TOWN OF CARMEL
ENVIRONMENTAL CONSERVATION BOARD

ENVIRONMENTAL CONSERVATION BOARD AGENDA

FEBRUARY 17, 2022 – 7:30 P.M.

REVISED: 2/10/2022

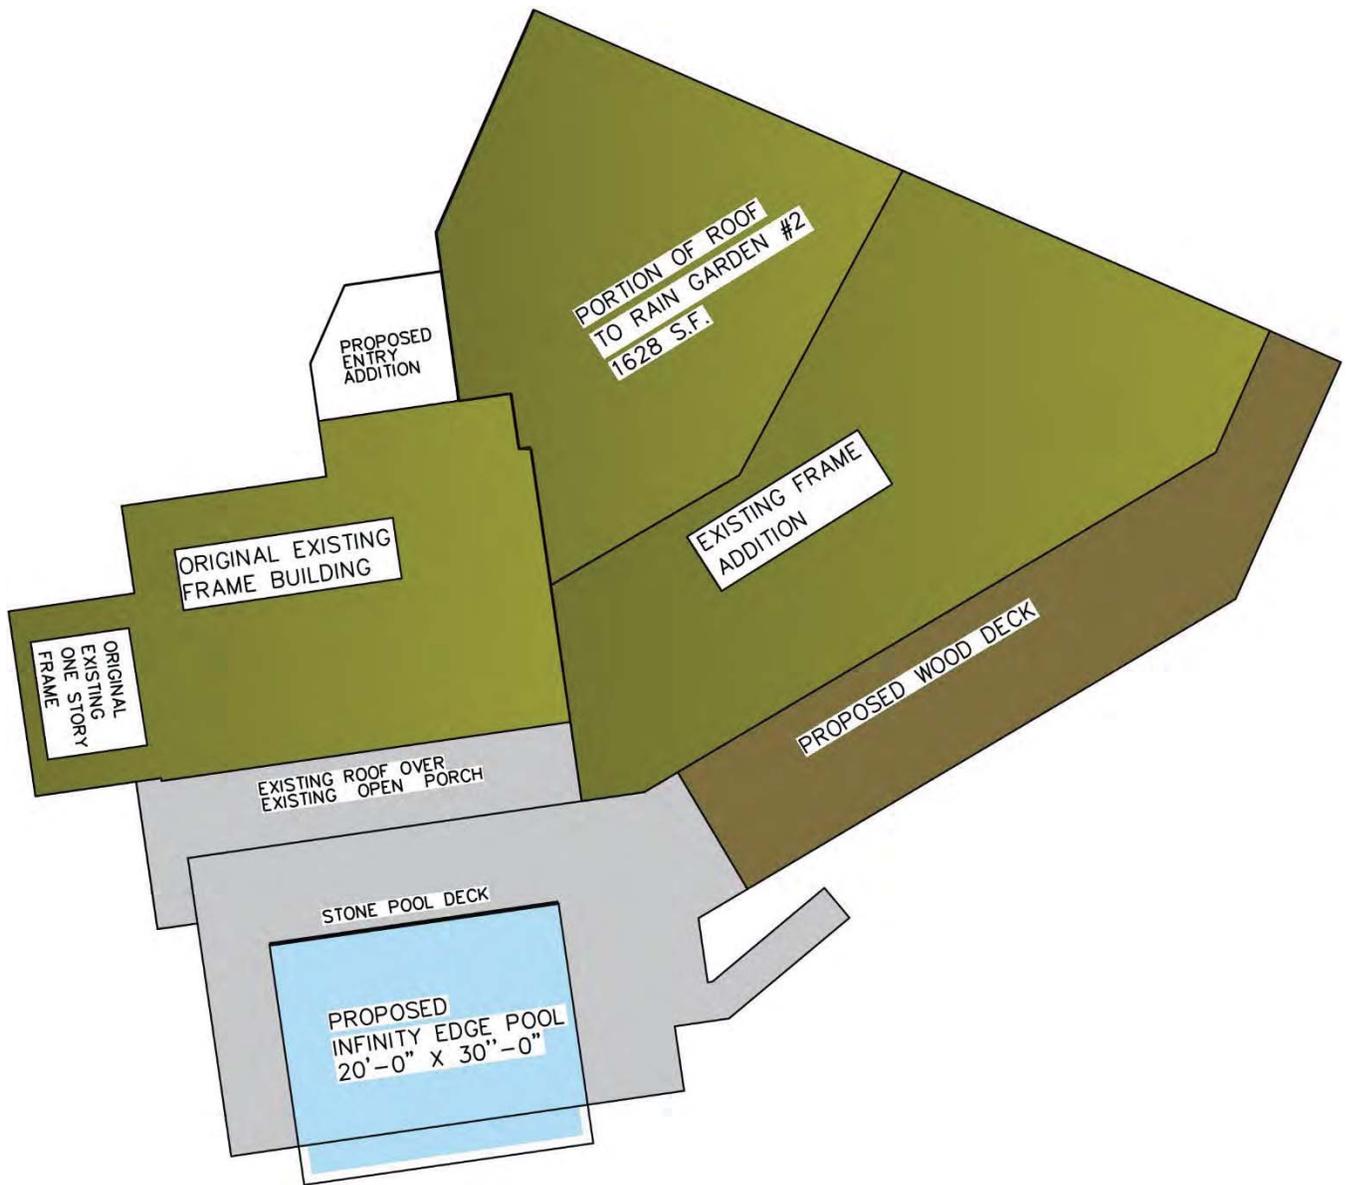
There will be some minor revisions to the Pool Deck shape and Front Addition for a total of 417 SF additional.

Rain Garden # 1 has been divided into Two Rain Gardens 1A & 1 B, to allow a pathway to the Lake.

The Site Plan and Calculations have been revised to show that we still meet the Rain Garden Requirements for the additional 417 SF.

Total Drainage Area	= 9160 SF	
Rain Garden #1A Drainage Area	= 2393 SF	
Rain Garden #1B Drainage Area	= 5139 SF	
Rain Garden #2 Drainage Area	= 1628 SF	(Front Portion of House as indicated in diagram)

1 GRADING & DRAINAGE PLAN
SCALE 1"=60'

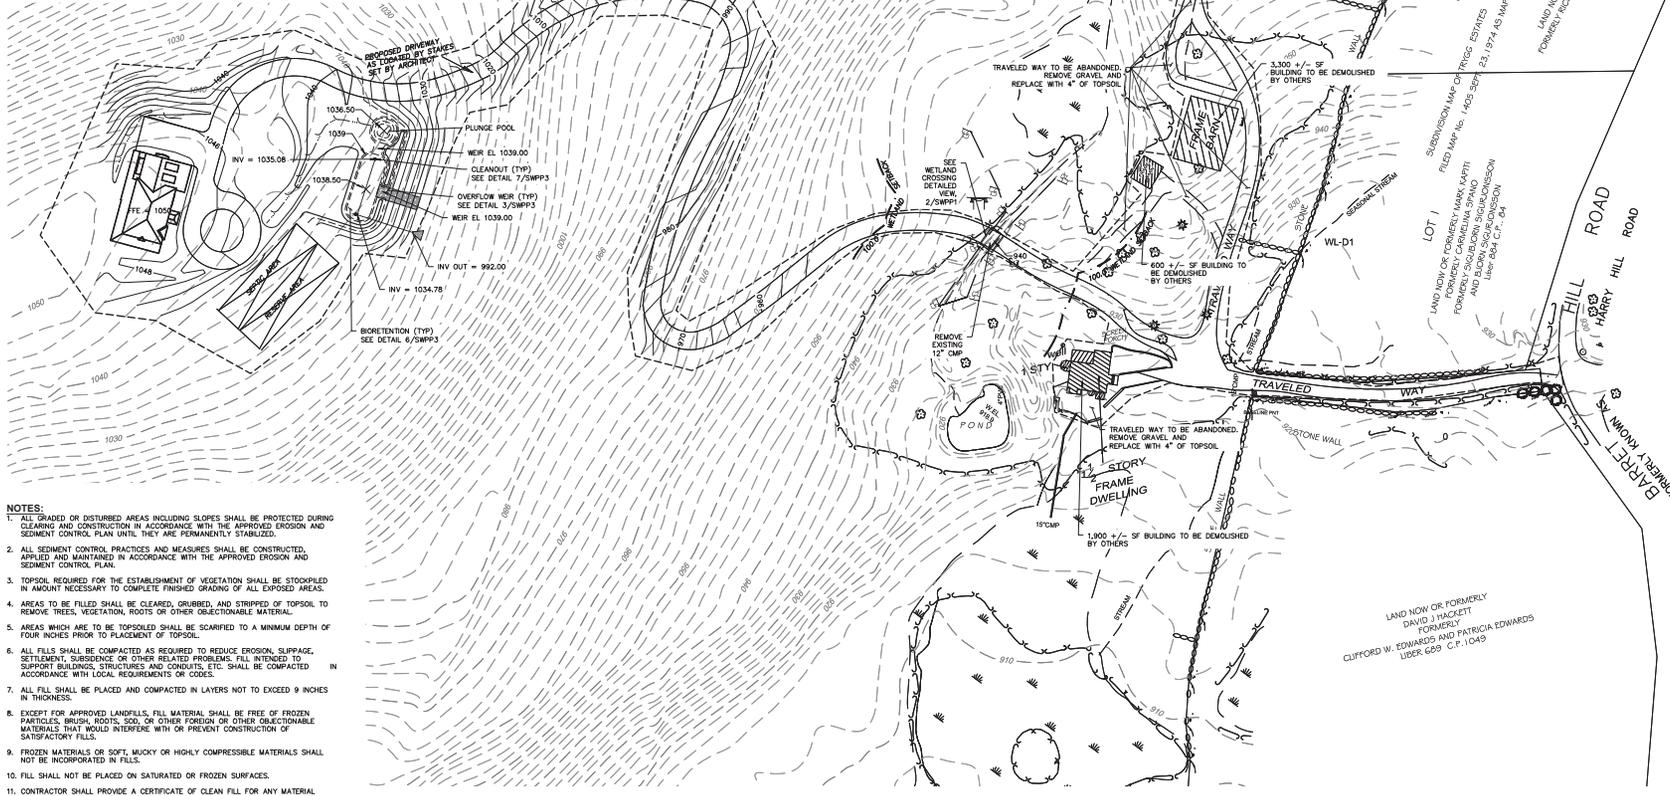
Please be advised that plans and documents have been revised as follows:

1. Notes have been added regarding placement of signs every 50 feet both sides of buffer along with a detail.
2. Buildings to be removed are indicated and square footage provided. These building locations were shown on the plans approved by the DEC.

3. Wetland flagging and silt fencing are shown along with the 100 foot wetland buffer.
4. The DEC approved their permit based upon their original inspection of the flagging that was reflected on the DEC permit. In that regard Ted Kozlowski has been contracted to inspect the wetlands to determine if the boundary has changed. The report of his inspection is attached and indicates that the boundary in fact has not changed.

5. See item # 2 above. Both barns are to be removed along with the existing house. As aforesated these buildings included in the area of disturbance reflected on the plans and included in the DEC permit.
